From: Allen, Jennifer (02) <<u>Jennifer.Allen2@balfourbeatty.com</u>> Sent: 20 April 2021 14:58 To: Lewis, Adam (Planning) <<u>Adam.Lewis@herefordshire.gov.uk</u>> Cc: Wager, Alastair <<u>alastair.wager@herefordshire.gov.uk</u>> Subject: {Disarmed} 203335 - Land at 83 Broomy Hill, Hereford

From: Hockenhull, Joel <<u>Joel.Hockenhull@balfourbeatty.com</u>> Sent: 24 November 2020 10:52 To: Wager, Alastair <<u>alastair.wager@herefordshire.gov.uk</u>> Subject: 203335 - Land at Broomy House, 83 Broomy Hill, Hereford,

SITE: TYPE:	Land at 83 Broomy Hill, Hereford, HR2 7AX Pre-application Advice
DESCRIPTION:	Proposed residential development of four detached market dwellings each with associated garaging & private gardens
APPLICATION NO:	191143
GRID REFERENCE:	OS 349558, 239324
APPLICANT: AGENT:	Mr & Mrs B Bushnell

Figure 1: Environment Agency Flood Map for Planning (Rivers and Sea), April 2019

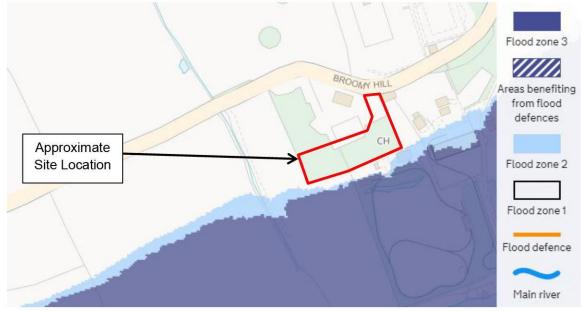
Review of the Environment Agency's Flood Map for Planning (Figure 1) indicates that the site is located within the low risk Flood Zone 1, however is adjacent to Flood Zone 2 and 3. Flood Zone 1 comprises land assessed as having less than a 1 in 1,000 annual probability of river flooding. Flood Zone 2 comprises land where the annual probability of flooding from fluvial sources is between 1% and 0.1% (between 1 in 100 and 1 in 1000). Flood Zone 3 comprises land where the annual probability of flooding from fluvial sources is greater than 1% (1 in 100).

Due to the steep sloping nature of the site, fluvial flood risk is likely to not be a concern for this site, thus we consider that a Flood Risk Assessment would not be required for this site. Review of the EA's Risk of Flooding from Surface Water map indicates that the site is also not at risk of surface water flooding.
